SA2026-1453

SUBJECT: Electric Substation Audit of PG&E Moss Landing Headquarters

CPUC SUBSTATION AUDIT FINDINGS

PG&E Moss Landing Headquarters

3. Otter Substation

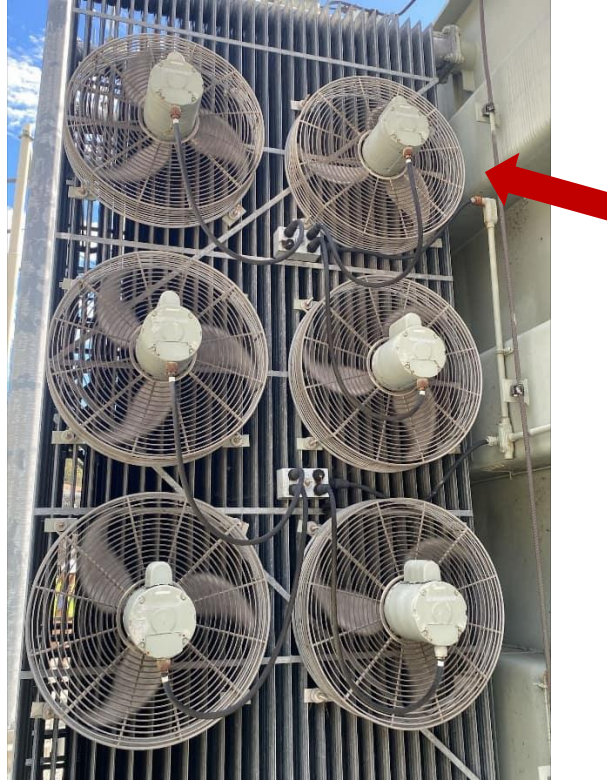
- 3.1. The station does not meet the wildfire defensible space Zone 1 clearance requirement of 30 feet.¹³

4. Viejo Substation

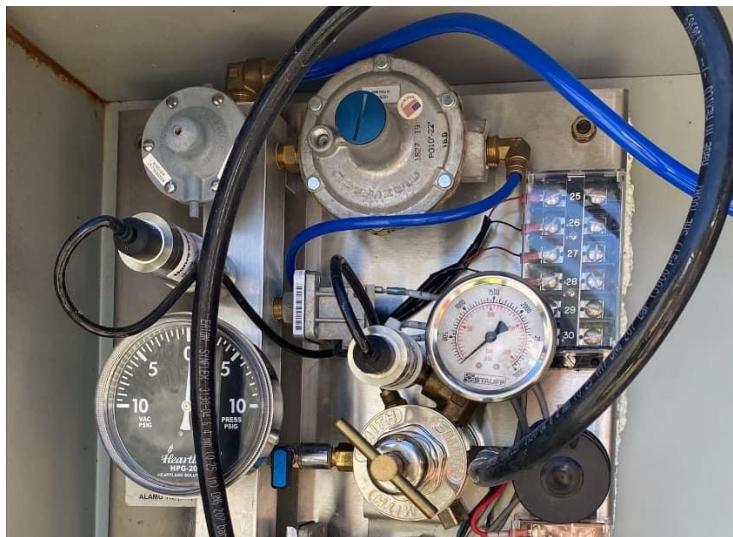
4.8. Monterey-Viejo 60kV Potential Transformer C Phase insulator is dirty. PG&E has existing Notification #133569250 for this issue.

10. Los Coches Substation

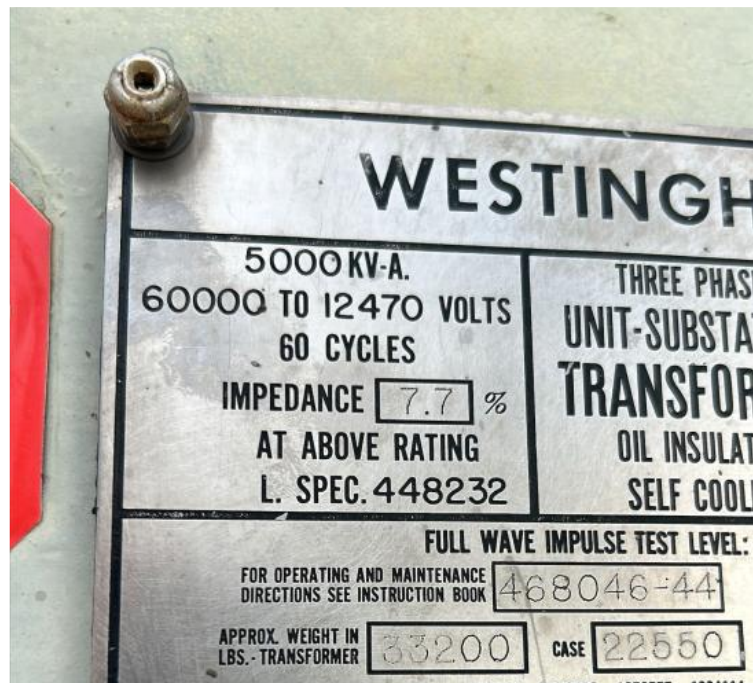
10.4. Transformer Bank 2 B Phase has a broken fan. PG&E has existing Notification #133657688 for this issue.

11. Gonzales Substation

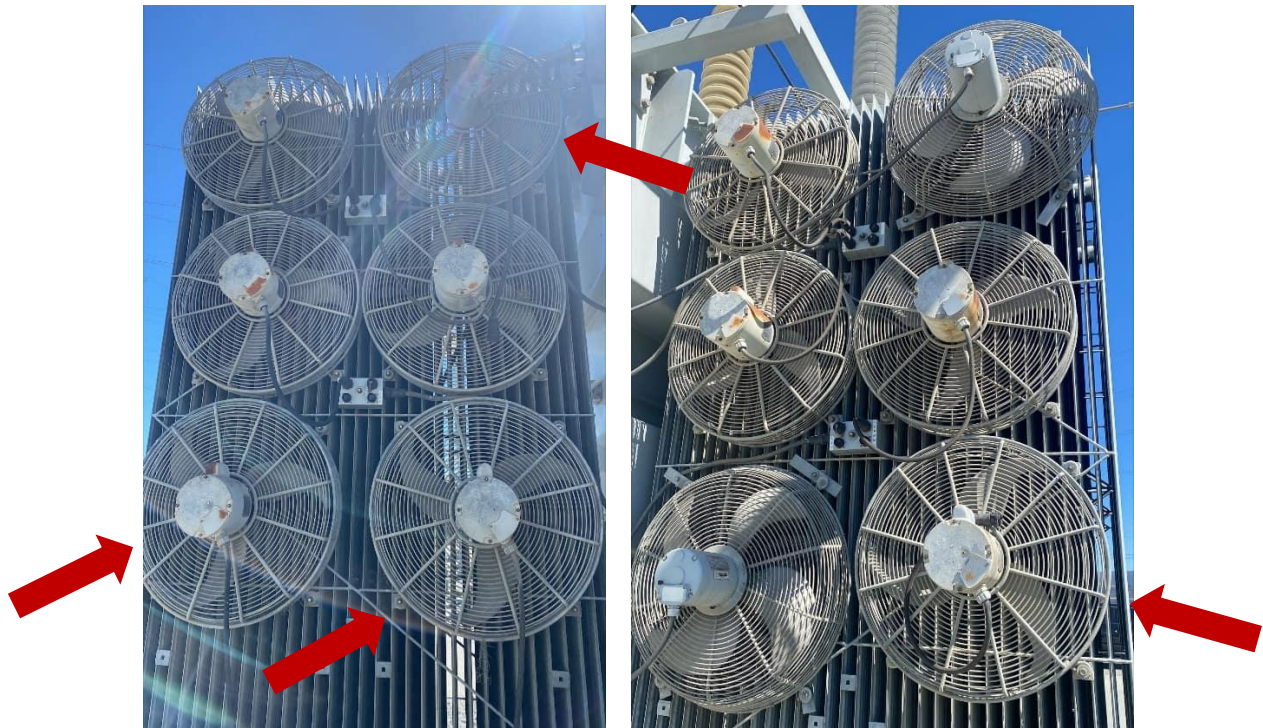
11.6. 60kV Potential Transformers A Phase, B Phase, and C Phase show signs of rust and corrosion. PG&E mitigated this issue in the field.

18. Laureles Substation

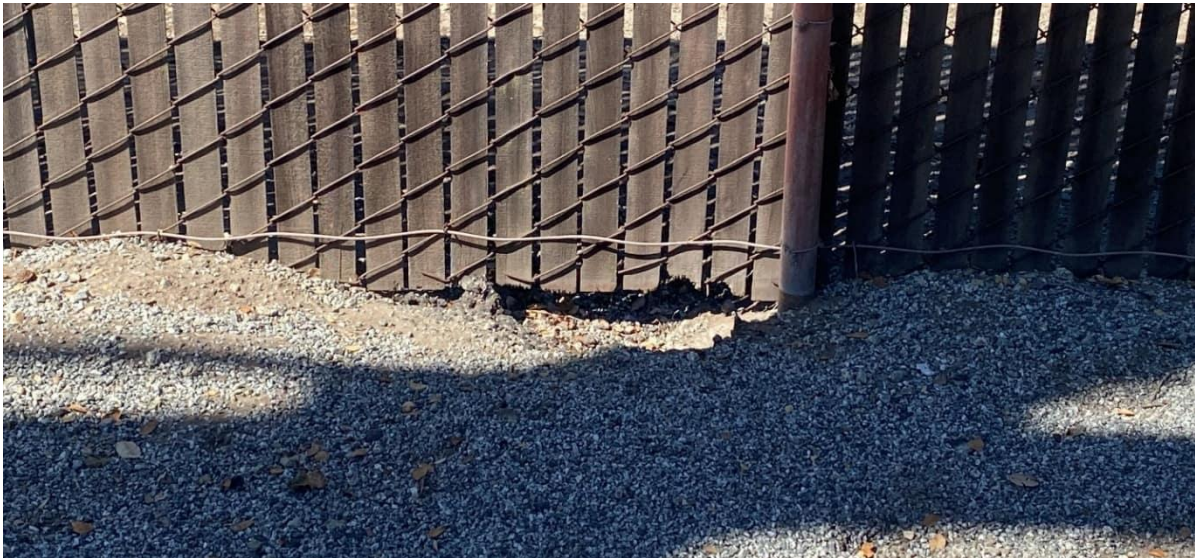
18.3. Transformer Bank 1 C Phase has an oil weep. PG&E has existing Notification #132825331 for this issue.
